Subject: Duke Energy Corporation
Catawba Nuclear Station, Unit 1
Docket Number 50-413
Request for Relief Number 02-003
Alignment Requirements When Component Inside
Surfaces Are Inaccessible

Catawba Nuclear Station
Request for Relief No. 02-003

Request for Relief No. 02-003

Component: Nuclear Service Water Piping (RN System) weld joint 1RN182-33

Figure 1

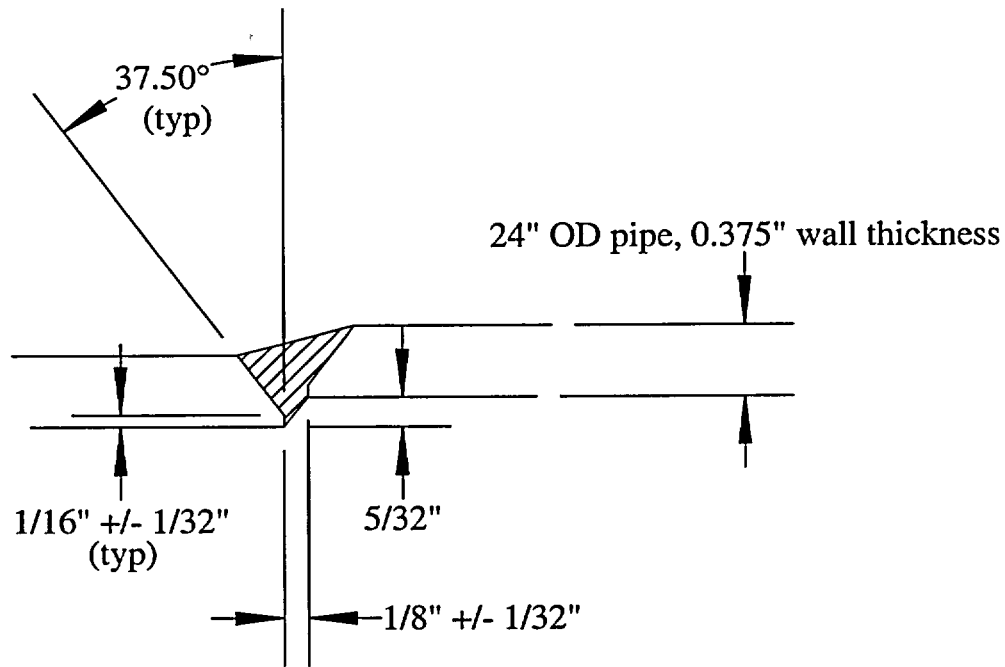
The circumferential butt weld joint 1RN182-33 was installed with a 5/32" mismatch that extended for about 18" around the top of the piping. (See Figure 1.) The internal joint surfaces at the bottom of the piping were flush, ie no observable mismatch. The root pass was made using the GTAW process, the fill passes made using a SMAW process. A slight buildup on the outside surface was faired into the adjacent base metal using a 3:1 taper. Visual and surface examinations were performed on both the root pass and

final pass. This is a Duke Class C, ASME Class 3 weld and is required to meet the requirements of ASME Section III, Subsection ND. In accordance with ND-4233, the maximum allowed mismatch at any one point around the circumference of the welded joint is 3/32".

Therefore, in accordance with 10CFR50.55a(g)(5)(iii), Duke Energy Corporation requests relief from the requirements of subparagraph IWA-7200 of the ASME Code Section XI, for the replacement of piping associated with weld joint 1RN182-33 in the Nuclear Service Water System.

An engineering evaluation of the existing condition was performed and has demonstrated that the current configuration is structurally acceptable. No changes to the existing joint configuration will be pursued.

Nominal stresses are low at this location primarily due to low deadweight, pressure, thermal and other design loadings. (See Table 1.) Vibrational stresses from normal operation are also low. Changes in stress concentration and stress intensification factors for the mismatch are not significant considering the margin between existing design and allowable stresses. An engineering evaluation has concluded that considering a penalty for the stress raiser (in terms of increased stress indices and an increased stress intensification factor) created by the mismatch, all ASME III, ND 3600 design requirements remain satisfied.

Consideration of repair was performed but rejected since the residual stresses from a forced fitup may counteract reduction in stresses from an elimination of stress concentration effects. Temporary welded attachments are typically used to force the circumferential shape necessary to achieve fitup. Residual stresses are developed in the joint after completion of the weld as the load is removed from these
